ROADWAY PLAN

MOKAPU SADDLE ROAD
Traffic Signals at H-3 On-Ramp
Fed. Aid Project No. STP-065-1(6)

"AS-BUILT"

C.O. 6

ROADWAY PLANS

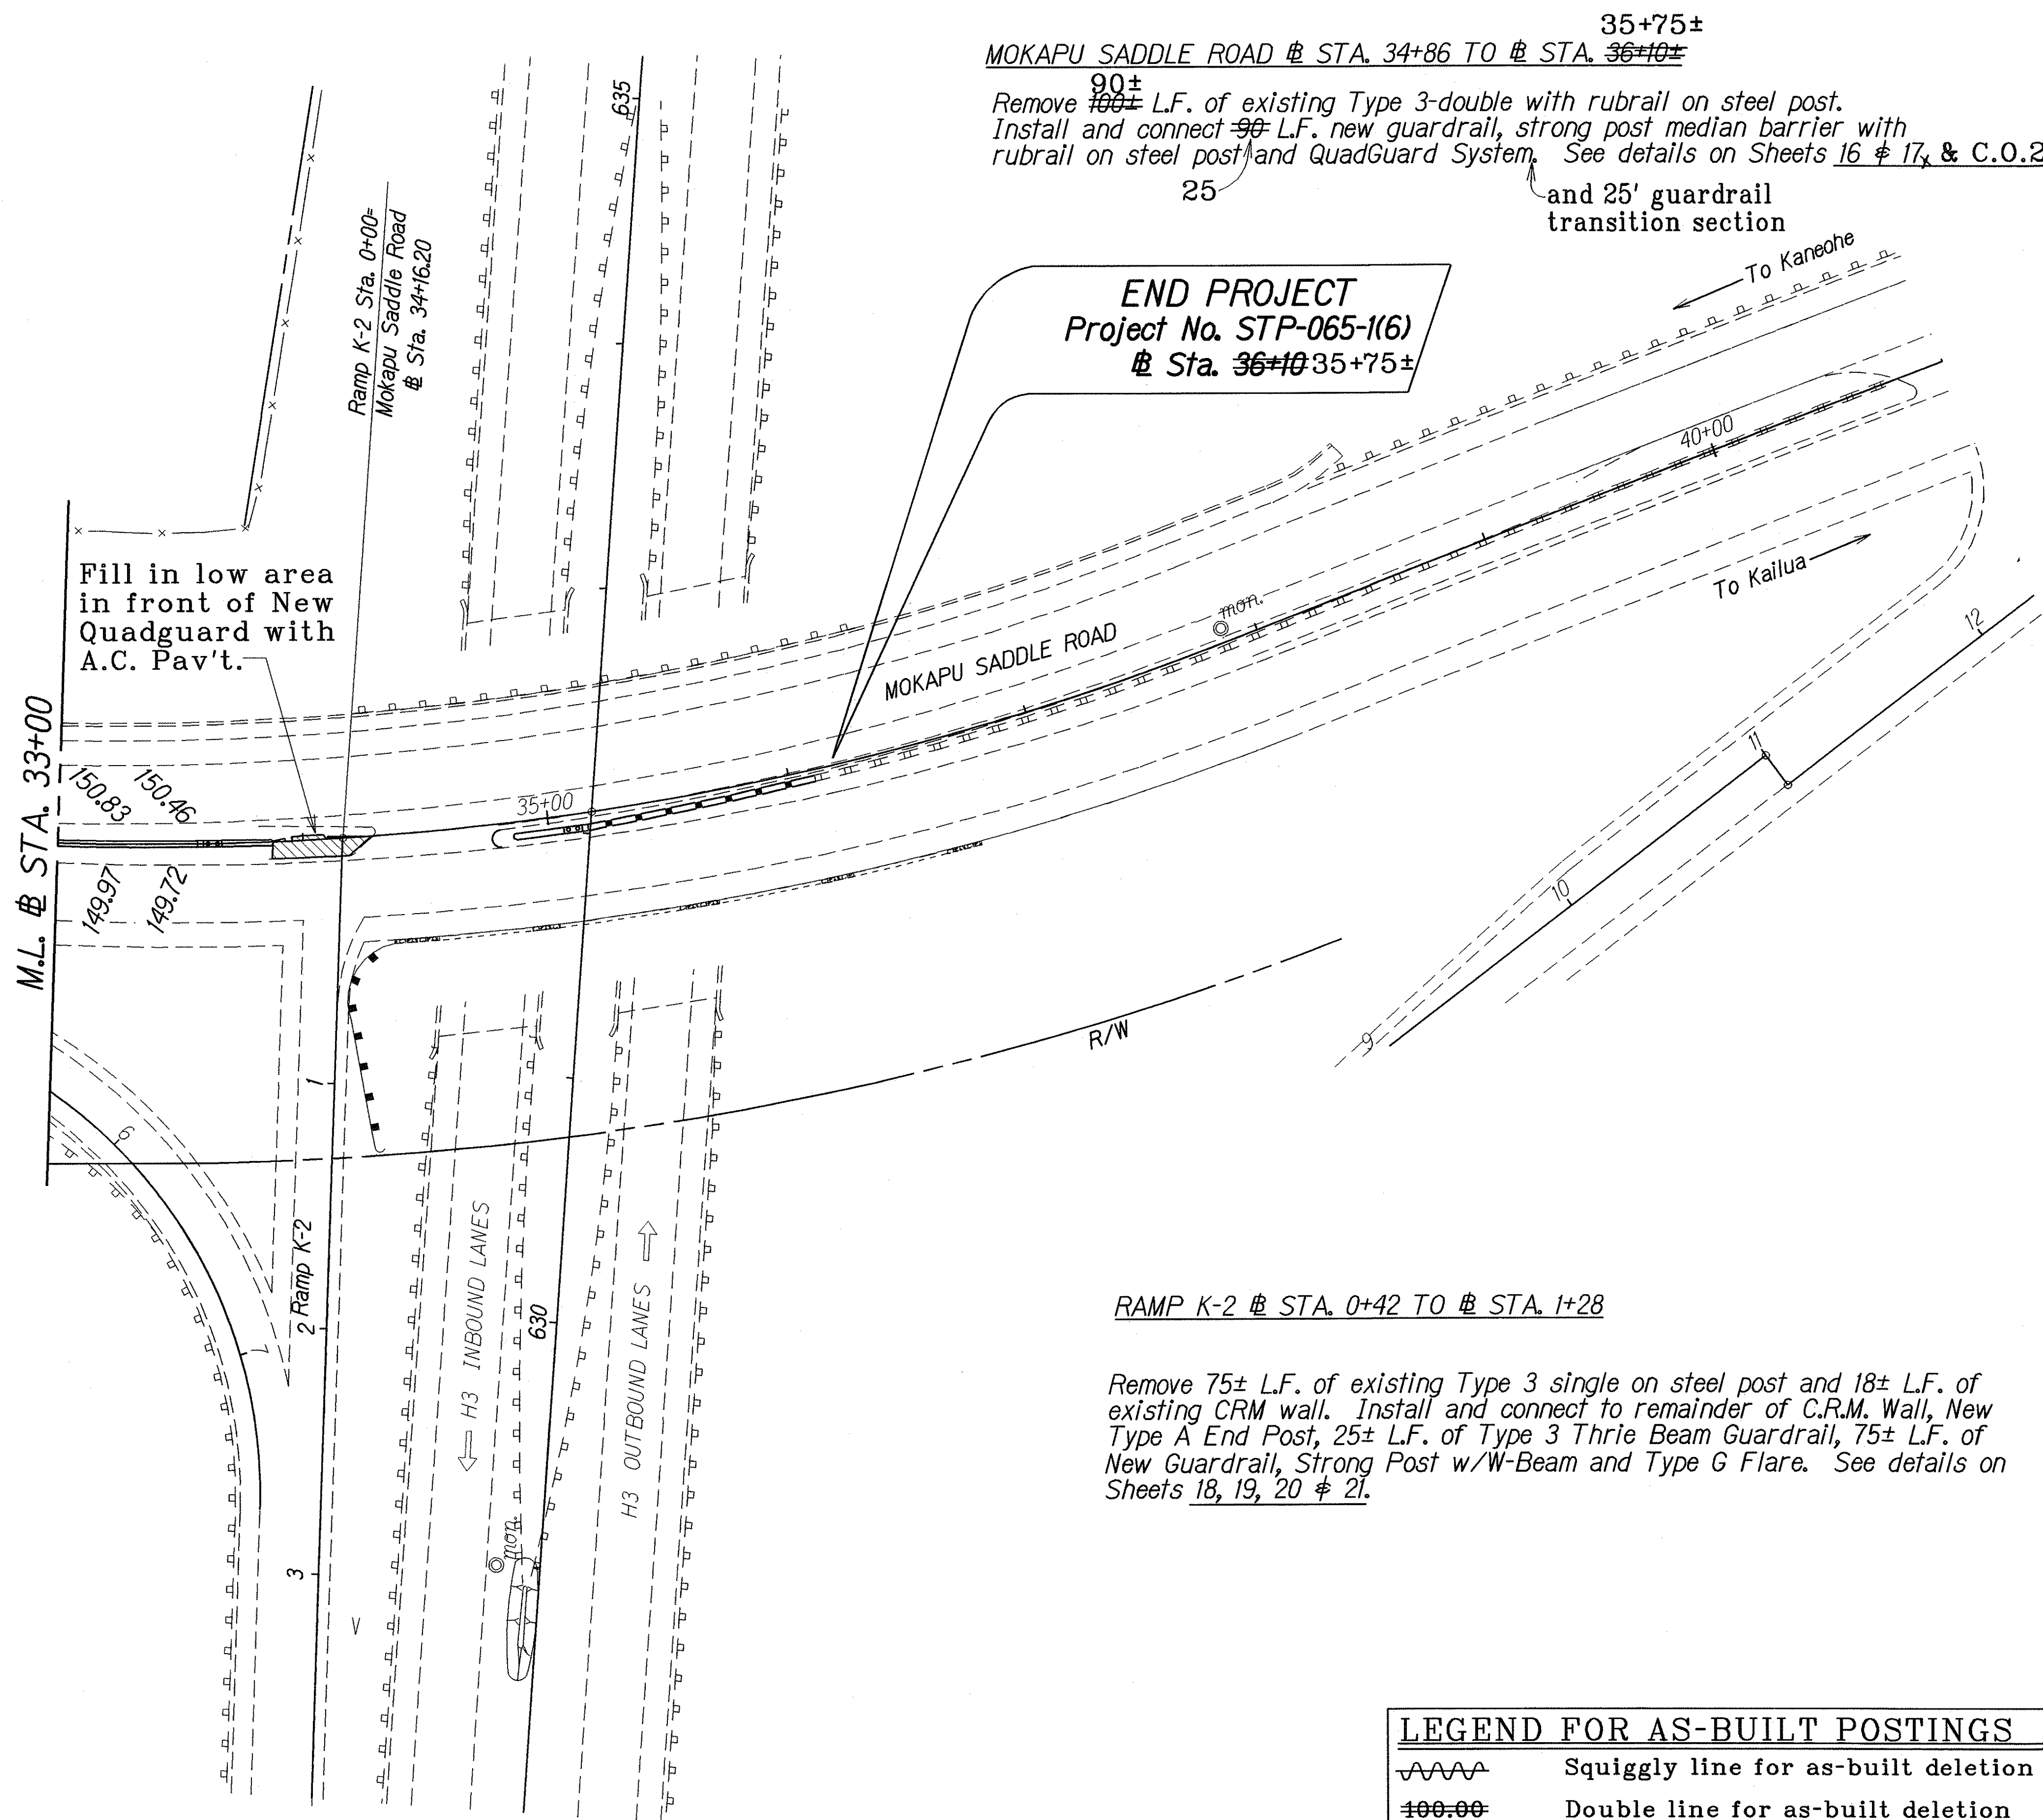
MOKAPU SADDLE ROAD @ STA. 34+86 TO @ STA. 35+75±
 Remove 90± L.F. of existing Type 3-double with rubrail on steel post.
 Install and connect 25± L.F. new guardrail, strong post median barrier with rubrail on steel post and QuadGuard System. See details on Sheets 16 & 17 & C.O.21S-1.
 and 25' guardrail transition section

Remove 75± L.F. of existing Type 3 single on steel post and 18± L.F. of existing CRM wall. Install and connect to remainder of C.R.M. Wall, New Type A End Post, 25± L.F. of Type 3 Thrie Beam Guardrail, 75± L.F. of New Guardrail, Strong Post w/W-Beam and Type G Flare. See details on Sheets 18, 19, 20 & 21.

Provide roadway grades at concrete barrier locations starting at Sta. 30+75 and ending at Sta. 33+50
